Product Change Notice

Issue Date: 28-October-2022

New dice replacement for Leadframe Seven Segment Display and Annunciator.

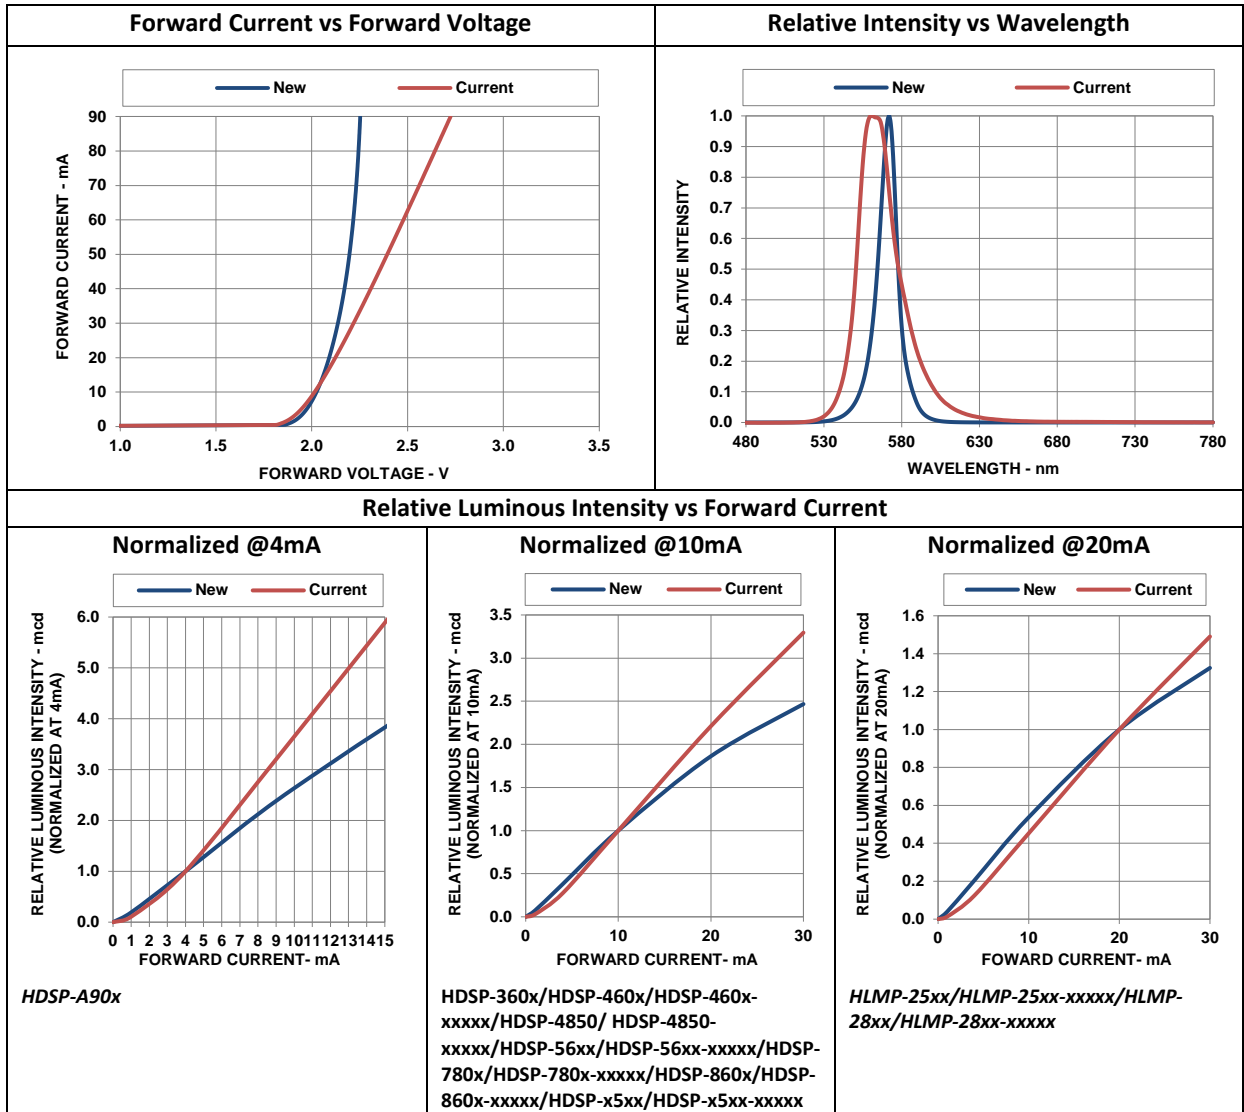
The new die (AlInGaP) will replace current die (GaP) for part numbers above.

1. Supply of assurance.
2. Obsolescence of existing Epi by dice supplier (Yellow color).

Group I (Green)

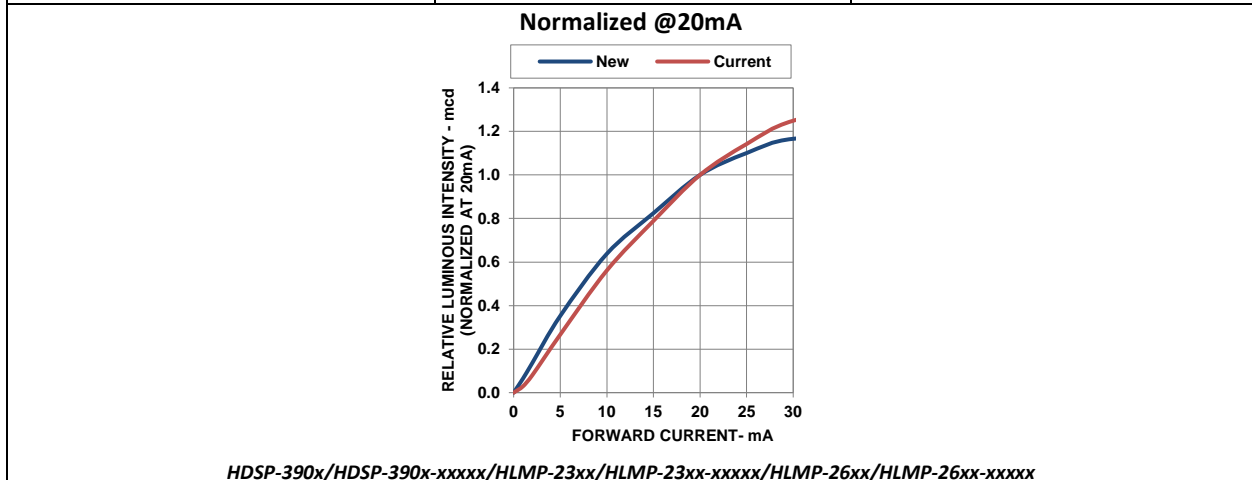
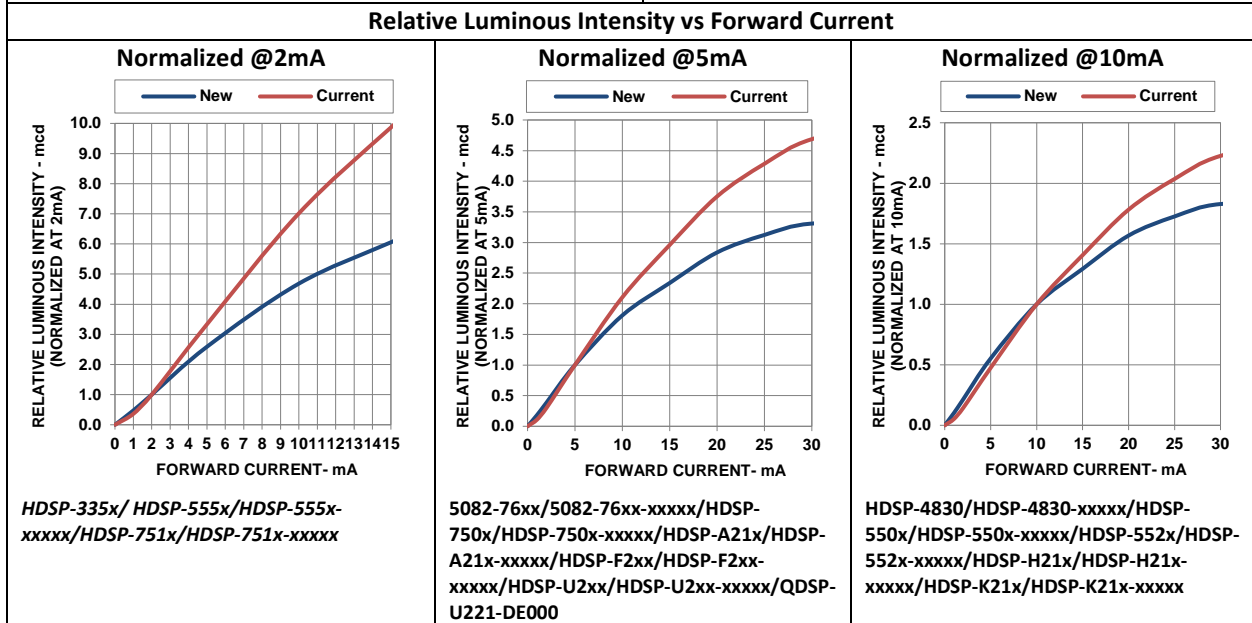
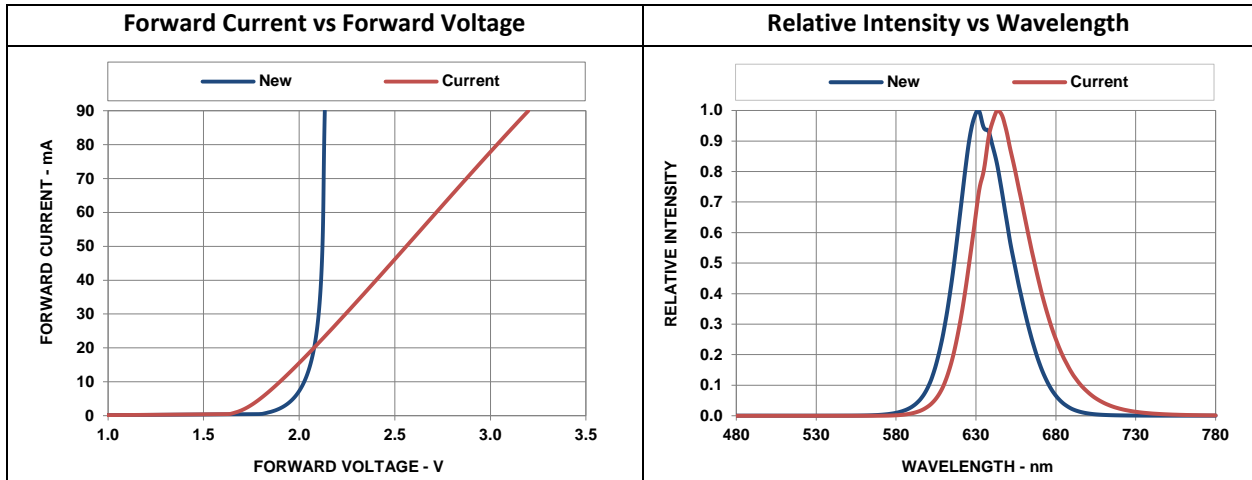
Following are changes in product characteristic:

1. Forward Current vs Forward Voltage
2. Relative Intensity vs Wavelength
3. Relative Intensity vs Forward Current
4. Peak forward current
5. 1 to 5 lv bin higher with the new die source

Part#	Peak forward current	
	Current die	New die
HDSP-A90x	45mA	90mA
HDSP-360x/HDSP-460x/HDSP-460x-xxxxx/HDSP-4850/ HDSP-4850-xxxxx/HDSP-56xx/HDSP-56xx-xxxxx/HDSP-780x/HDSP-780x-xxxxx/HDSP-860x/HDSP-860x-xxxxx/HDSP-x5xx/HDSP-x5xx-xxxxx/ HLMP-25xx/HLMP-25xx-xxxxx/HLMP-28xx/HLMP-28xx-xxxxx	90mA	90mA

Group II (Red)

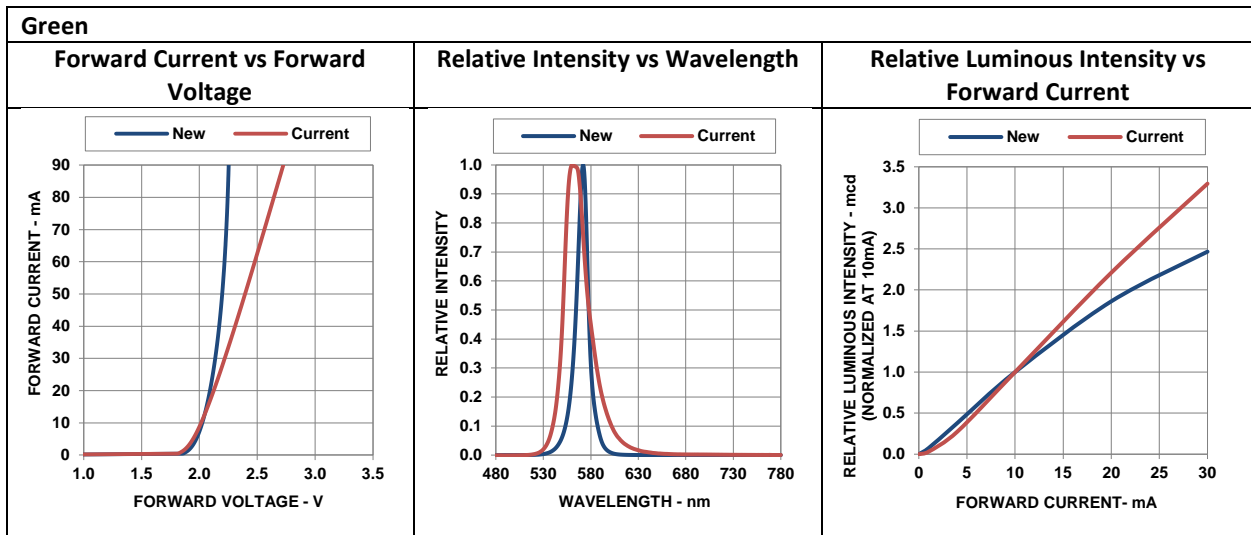
Part#	Vf max		Peak forward current	
	Current die	New die	Current die	New die
HDSP-335x/ HDSP-555x/HDSP-555x-xxxxx/HDSP-751x/HDSP-751x-xxxxx	2.5V@20mA	2.5V@20mA	45mA	90mA
HDSP-390x/HDSP-390x-xxxxx	3.5V@100mA	2.5V@20mA	135mA	90mA
5082-76xx/5082-76xx-xxxxx/HDSP-750x/HDSP-750x-xxxxx/HDSP-A21x/HDSP-A21x-xxxxx/HDSP-F2xx/HDSP-F2xx-xxxxx/HDSP-U2xx/HDSP-U2xx-xxxxx/QDSP-U221-DE000/HDSP-4830/HDSP-4830-xxxxx/HDSP-550x/HDSP-550x-xxxxx/HDSP-552x/HDSP-552x-xxxxx/HDSP-H21x/HDSP-H21x-xxxxx/HDSP-K21x/HDSP-K21x-xxxxx	2.5V@20mA	2.5V@20mA	90mA	90mA
HLMP-23xx/HLMP-23xx-xxxxx/HLMP-26xx/HLMP-26xx-xxxxx	2.6V@20mA	2.6V@20mA	90mA	90mA

Part identification:

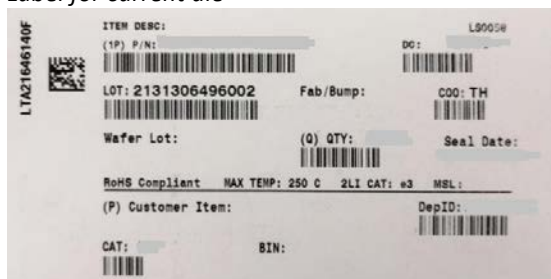
Label for current die

Label for new die

Prefix "E" will be added to the Lot number
